Access Compliance Report

Public Rights-of-Way

(Curb Ramps)

Intersection ID: 10029213	Main Street: JOHN_PRICE_RD	Cross Street: N/A	Location: SE
ADA ID: 70CDF0D11CF5	Ramp Type: PerpDiag	Initial Pass/Fail: Pass	Overall Compliance: No
Codes/Mitigation Info/Possible Solution		Field Measurements/Component Compliance	
Severity Score: 12.75

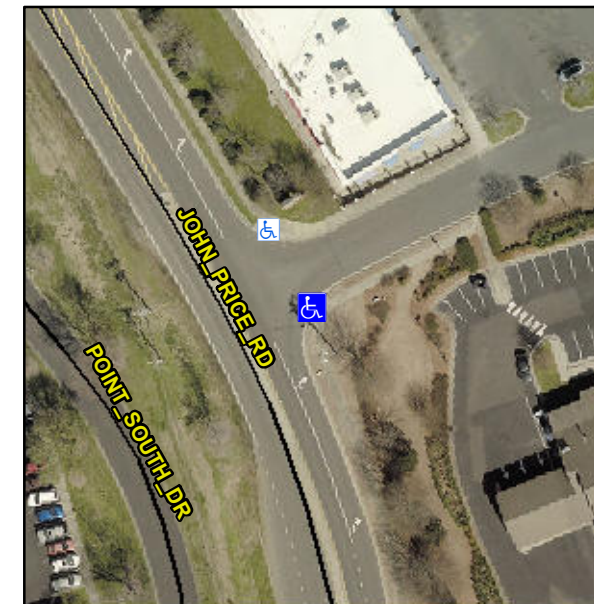
R304.5.3, R304.2.1, R304.2.2-Perp, R304.3.2-Para, R305.1.4

Compliance	Description	Data	Compliance	Description	Data
N/A	Ramp Length (in)	83.0	Yes	Ramp Slope (%)	5.5
Yes	Ramp Width (in)	48.0	No	Ramp XSlope (%)	2.3
N/A	Flare Type LT	Sloped	N/A	Flare Type RT	N/A
N/A	Flare Slope LT (%)	5.7	Yes	Flare Slope RT (%)	9.8
N/A	Flare Traversable LT?	Yes	N/A	Flare Traversable RT?	Yes
No	Landing Length (in)	N/A	Yes	DWS Provided?	Yes
No	Landing Width (in)	N/A	Yes	DWS Contrast?	Yes
No	Landing Slope (%)	N/A	No	DWS Length (in)	23.5
No	Landing X Slope (%)	N/A	No	DWS Full Width?	No
N/A	Landing Curb? (Y/N)	No	Yes	DWS Offset (in)	1.0
N/A	Shared Landing?	No			
Yes	Gutter Ponding?	No	Yes	Gutter Slope (%)	1.7
Yes	Gutter Lip Ht (in)	0.0	Yes	Gutter X Slope (%)	1.9
N/A	Painted X Walk1?	No	N/A	Painted X Walk2?	No
	X Walk 1 Direction	To N		X Walk 2 Direction	To W
N/A	X Walk 1 Width (in)	N/A	N/A	X Walk 2 Width (in)	N/A
	X Walk 1 Slope (%)	1.9		X Walk 2 Slope (%)	0.8
	X Walk 1 X Slope (%)	1.2		X Walk 2 X Slope (%)	2.2

N/A	Ramp inside XWalk1?	N/A	N/A	Ramp inside XWalk2?	N/A
	Road Slope (%)	1.2	N/A	Clear Space?	Yes
	Road X Slope (%)	1.1	N/A	Clear Space to XWalk (in)	N/A
Yes	Any Obstructions?	No	Yes	Storm Grate/Utility Hazard?	No
	Obstruction Type			Storm Grate/Utility Type	
		N/A			N/A
		Yes		Surface Condition? (G/P)	Good

Remove & Replace Curb Ramp With Two New Directional Ramps or Equivalent.
